ADDENDUM #1

Suffolk Transit Hub/Bus Shelter

Contract No. 2014-00091-CN

IFB Number 2014-00091-CN for the construction of Suffolk Transit Hub / Bus Shelter is hereby amended/clarified as follows:

COLUMN WRAP - PLAN & ELEVATION

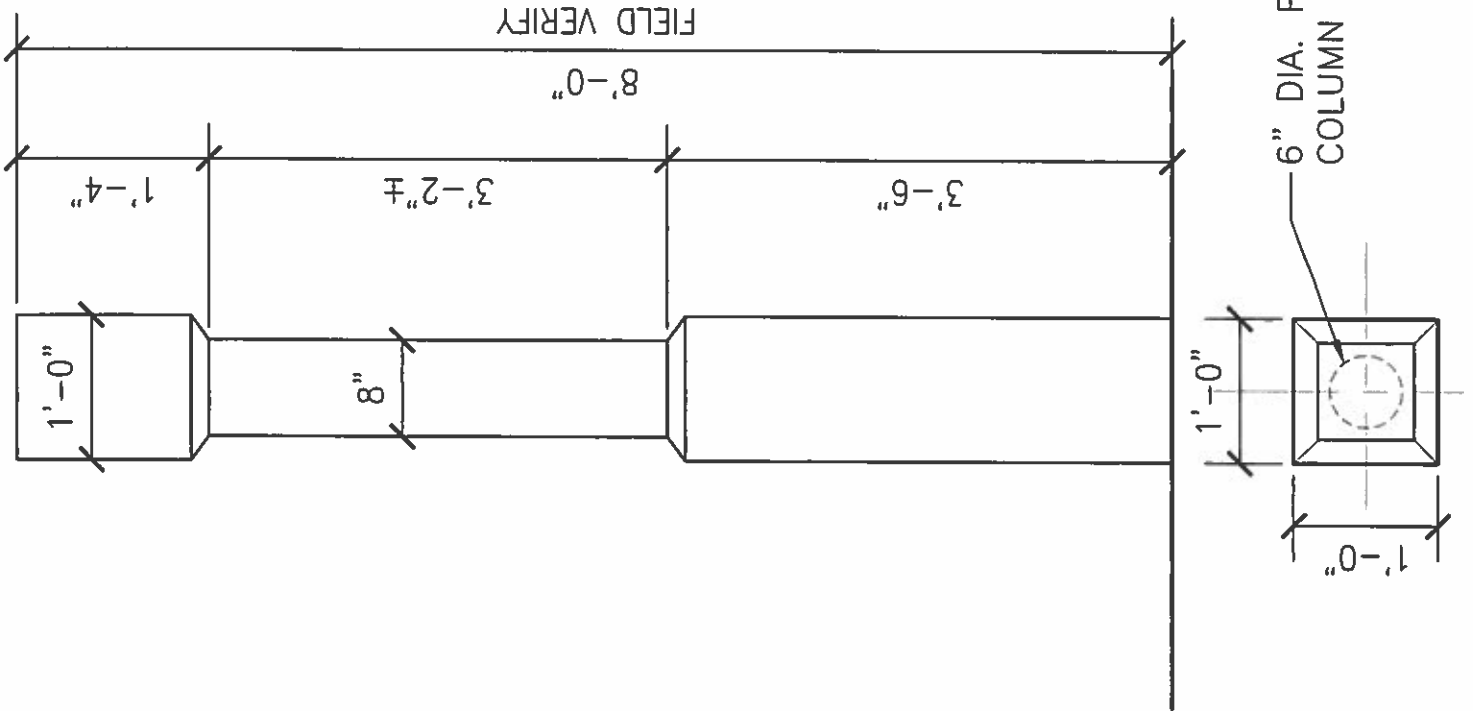
Question: Can the Architect provide more information/detail on the columns around the building? Detail 2-A2 does not provide much information, and it was mentioned in the Pre-Bid Conference that the columns should match the train station.

Answer: *See the attached sketch to clarify the column wraps at the bus shelter building perimeter.*

COLUMN WRAP BASIS OF DESIGN:
"ROYAL WRAP" PORCH COLUMN
COVERS, CRAFTSMAN STYLE, PLAIN,
NON-TAPERED SQUARE WITH
CUSTOM SIZE BASE AND CAP BY
"ARCHITECTURAL MALL" OR EQUAL
